P139-HD

DIGITAL AUDIO SYSTEM

BELL 204 / 212/ 412 INSTALLATION

MDL GA212 Rev A STC SR02270SE

NOTES:

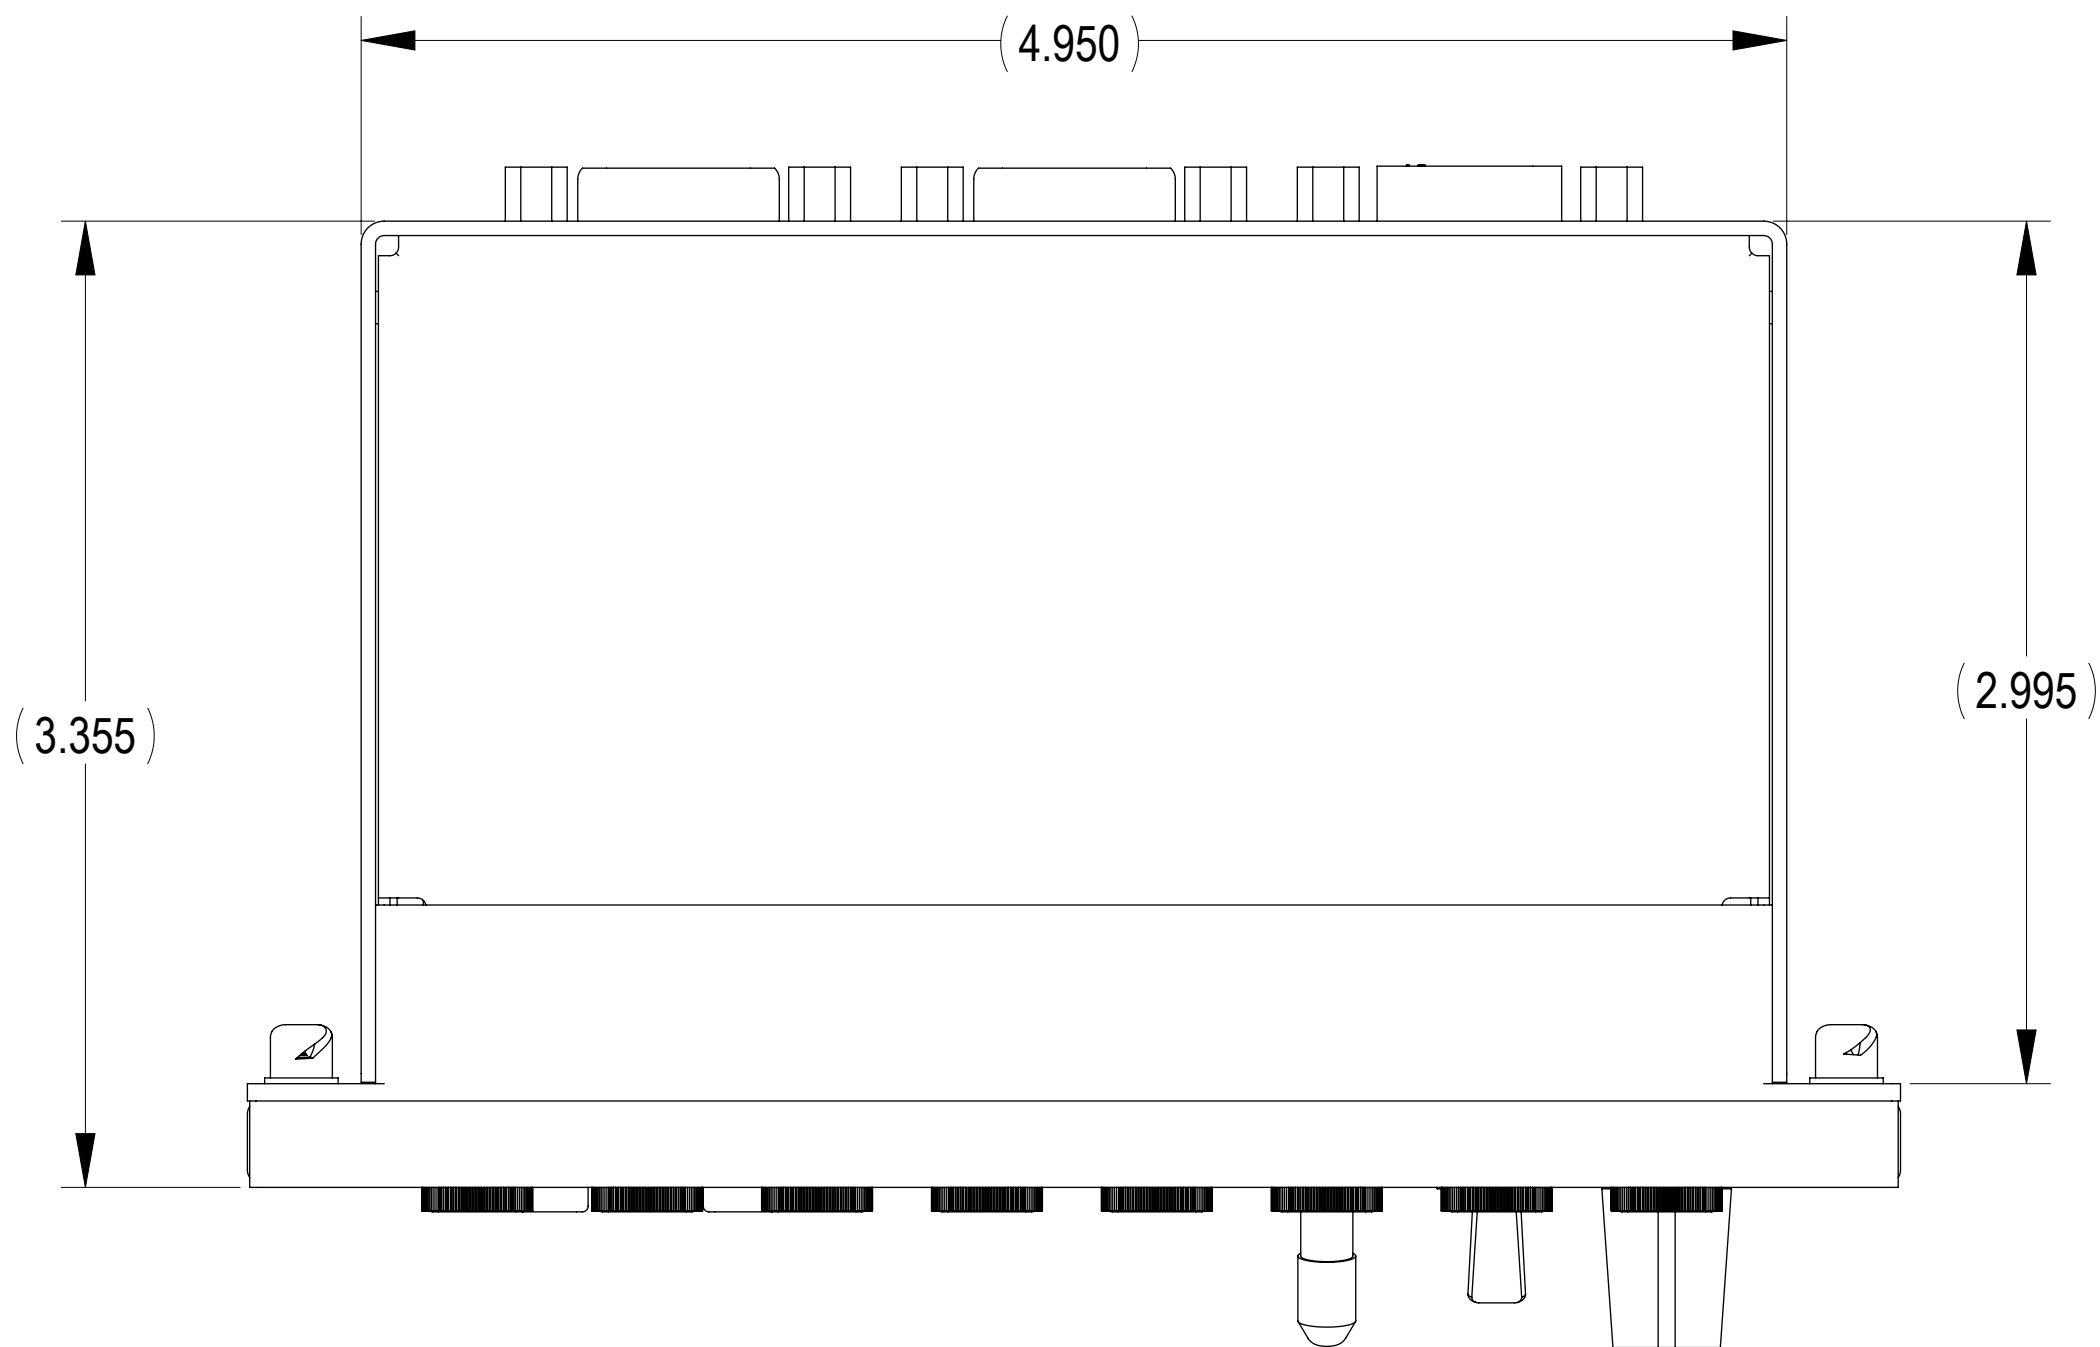
G13115: Revised labeling notes to engineering standards.

REVISIONS		
REV	DESCRIPTION	APPROVED/DATE
A	ADDED P/N G13115NS	10/15/12 CLB
B	REVISED NOTES	3/26/14 CLB
